Access Compliance Report Public Rights-of-Way (Curb Ramps)

Main Street: AIROSO_ST Cross Street: ANDAZA_ST Location: W

ADA ID: RPRK211203120113 Ramp Type: Type 1 - Perpendicular Initial Pass/Fail: Pass Overall Compliance: No Severity Score: 0

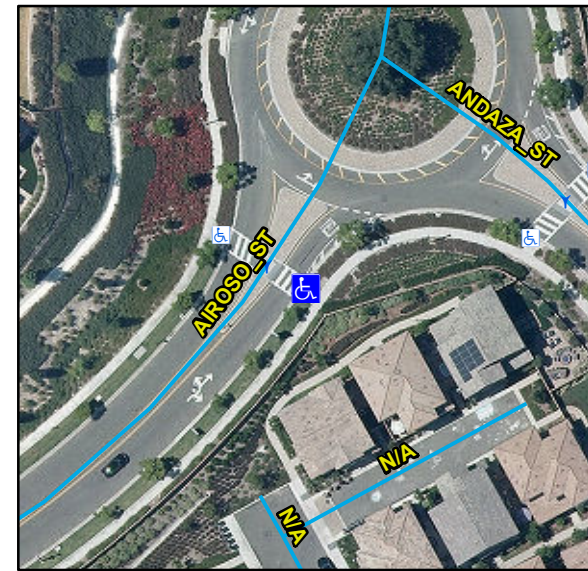
Remove & Replace Landing.
